Town of East Hartford

ADDENDUM N^o. 03

**Burnside Avenue Bus Shelters
Bid No. 16-23**

Issued June 22, 2016

DRAWING PREPARED BY:			
		PLAN & ELEVATION VIEWS OF MODEL AL7.5/02BVSP PREFABRICATED SHELTER	
KR	6-13-2016	BB	6-13-2016
DRAWN BY:	DATE:	CHECKED BY:	DATE:
SCALE:	MATERIAL:	DRAWING NO.	
		100	
COLUMBIA EQUIPMENT COMPANY 72 Albany Avenue, Freeport, NY 11520 TEL # (516) 442-3340

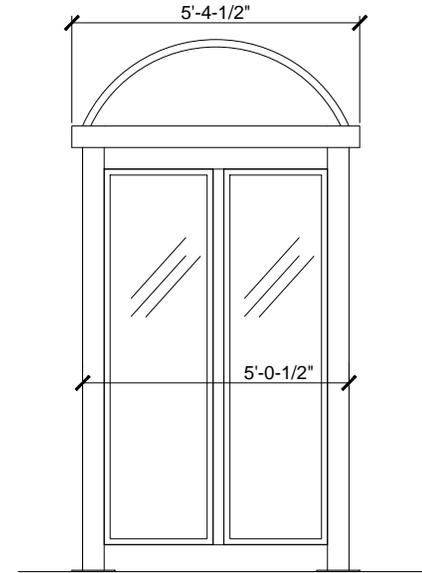
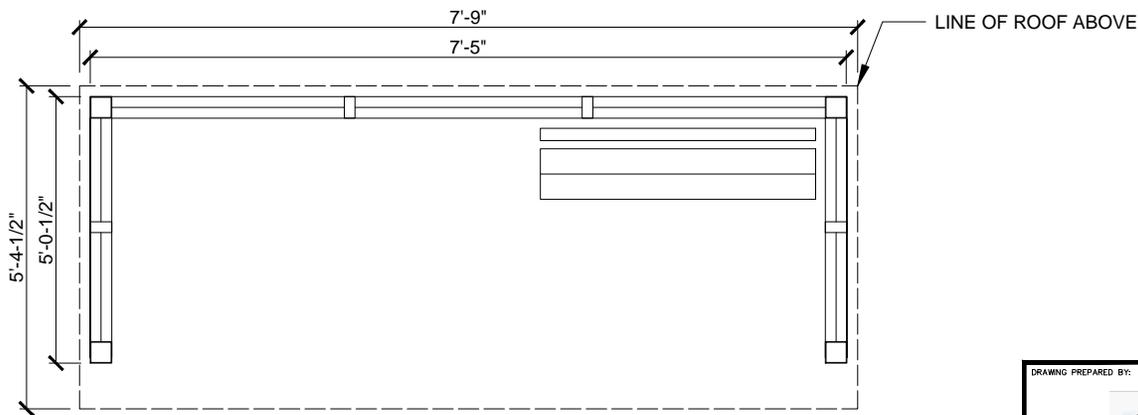
- The Town has decided to allow Model AL7.5/02BVsp (by the Columbia Equipment Company) as an equivalent shelter, as allowed under item 15 of the *Instructions for Construction and/or Labor Service Bids* (Page 10 of 191).

GENERAL: All shelters shall be AL7.5/02BVsp/ Series, as manufactured by the Columbia Equipment Company, Inc. Freeport, NY. Dimensions shall be: 7' 9" minimum overall length (outside of fascia to outside of fascia) by 5'- 4 1/2" minimum overall width (outside of fascia to outside of fascia) by 7'- 0" high to underside of fascia. Shelters shall be non-cantilevered. Shelters shall be open in front.
